DOE-0198-05

**TRANSMITTAL OF RESPONSE TO OHIO ENVIRONMENTAL PROTECTION
AGENCY (OEPA) COMMENT ON THE 2003 SITE ENVIRONMENTAL REPORT
COMMENT RESPONSES**

**RESPONSE TO
OHIO ENVIRONMENTAL PROTECTION AGENCY
COMMENT ON THE
2003 SITE ENVIRONMENTAL REPORT
COMMENT RESPONSES**

**FERNALD CLOSURE PROJECT
FERNALD, OHIO**

FIGURE 1. TOTAL URANIUM CONTROL CHART FOR CELL 3 HTW (Well 12340)

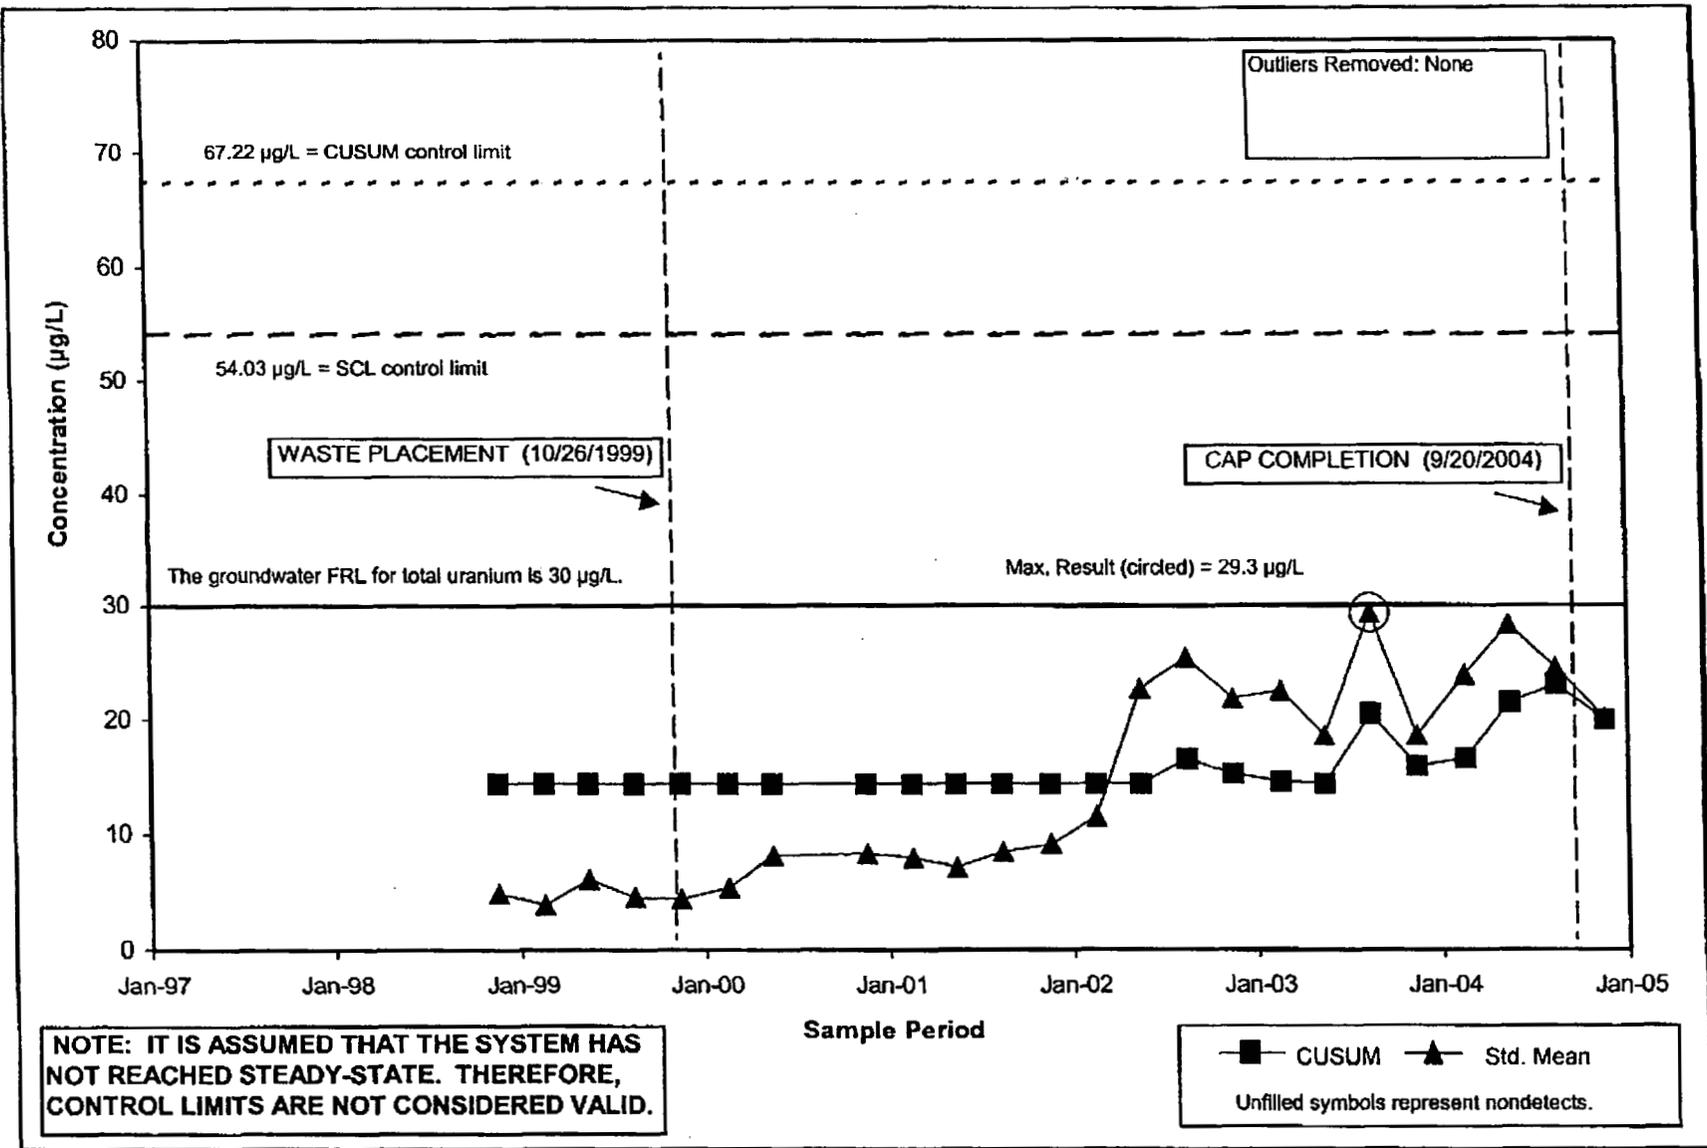
- 2) In general from a statistical stand-point, steady-state conditions in the groundwater (perched water and Great Miami) have not been reached regarding OSDF monitoring. Therefore, baseline conditions cannot be established at this time. Although steady-state conditions, which are a requirement of control charting, have not been reached, for informational purposes control charts will continue to be prepared and included in the annual site environmental reports for the horizontal till wells and the Great Miami Aquifer wells, as required. Control limits will be based on all data (i.e., data through 2004 is considered baseline sampling data for Cells 1 through 5). A note will be included on control charts to indicate that steady-state conditions have not been reached and that control limits are not considered valid at this time. It is expected that when sufficient data have been collected to indicate that a steady-state condition has been reached, final control limits will then be determined. For an example control chart, refer to Figure 1 in Enclosure 2.
